ADDENDUM 1  
DECEMBER 2010

# **Specification for Threading and Gauging of Rotary Shouldered Thread Connections**

ANSI/API SPECIFICATION 7-2 (FORMERLY IN SPEC 7)  
FIRST EDITION, JUNE 2008

# Addendum 1 to Specification for Threading and Gauging of Rotary Shouldered Thread Connections

Figure F.1 — Thread forms for 90-V-050, 90-V-084 and V-076

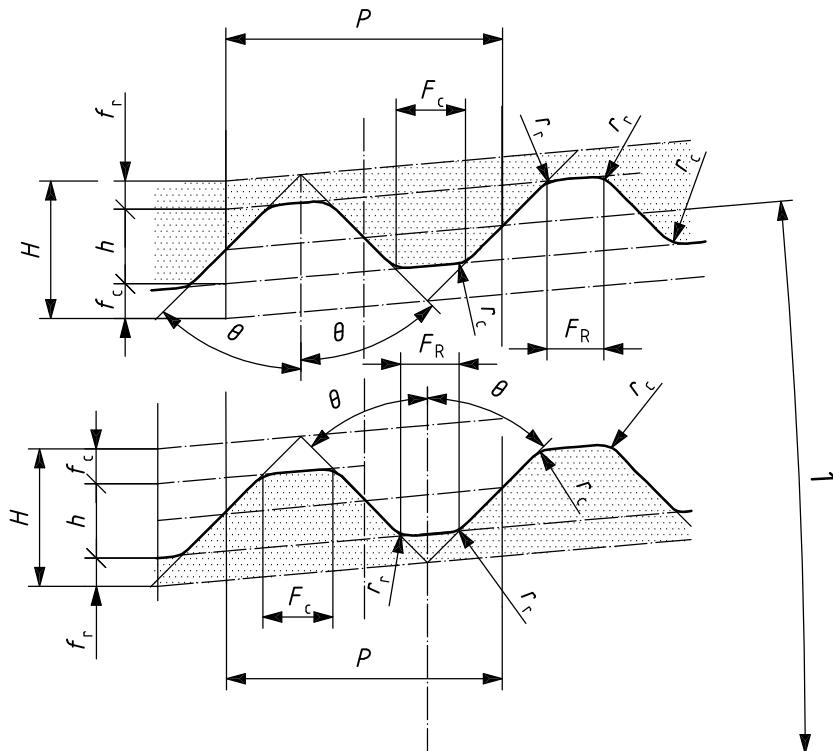
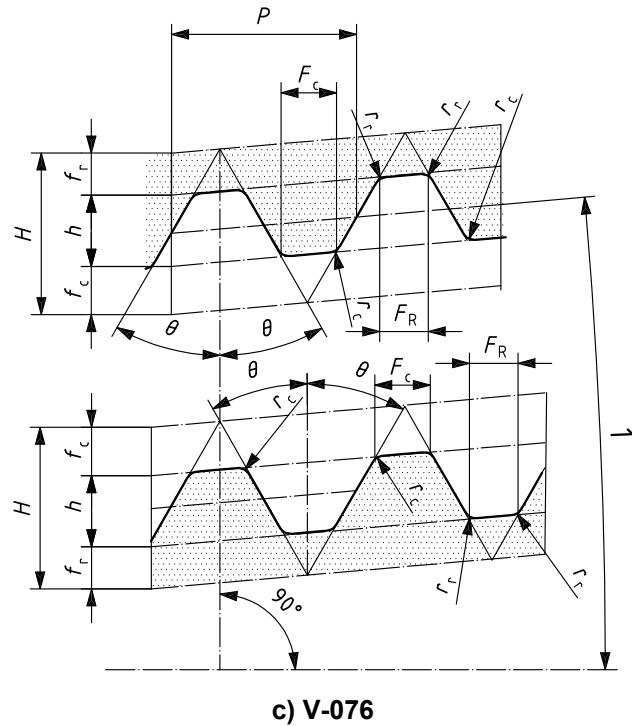
Annex F, *Replace completely (see below)*

**Figure F.2 — Pin Cylinder Radius**

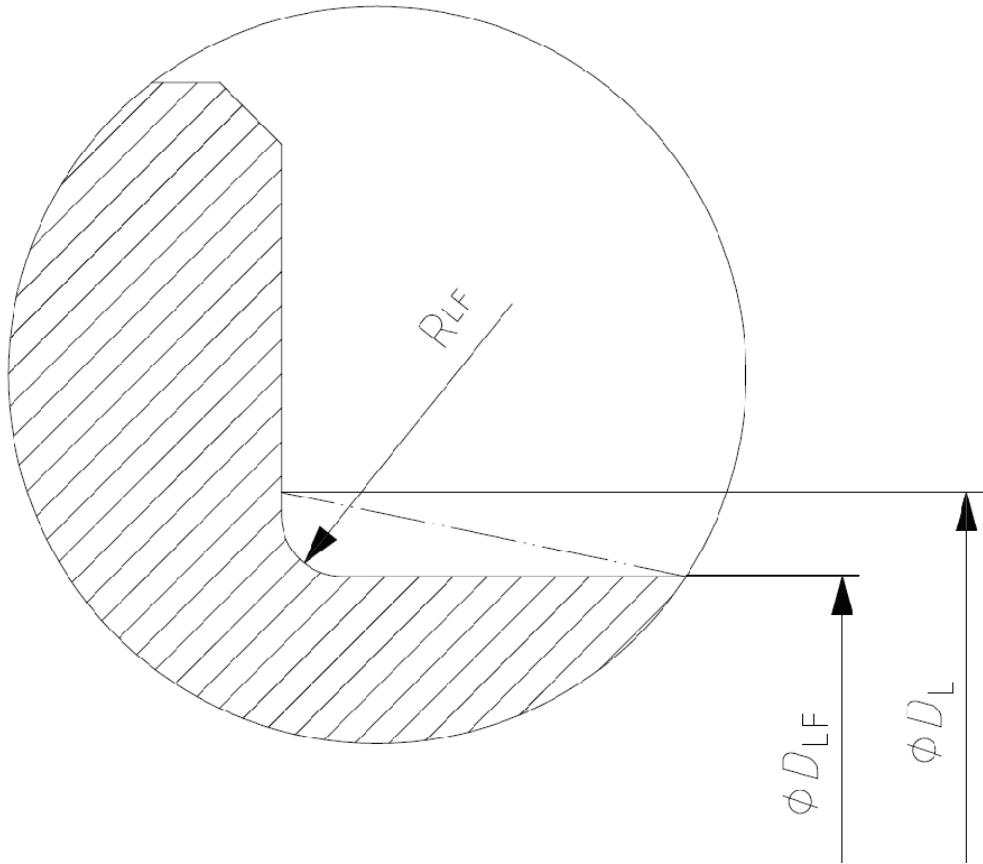
The pin cylinder radius of some of these connections differs from the definition in clause 6 of this Standard: the differences are shown in the notes of tables F.5 and F.6, and in figure F.2.
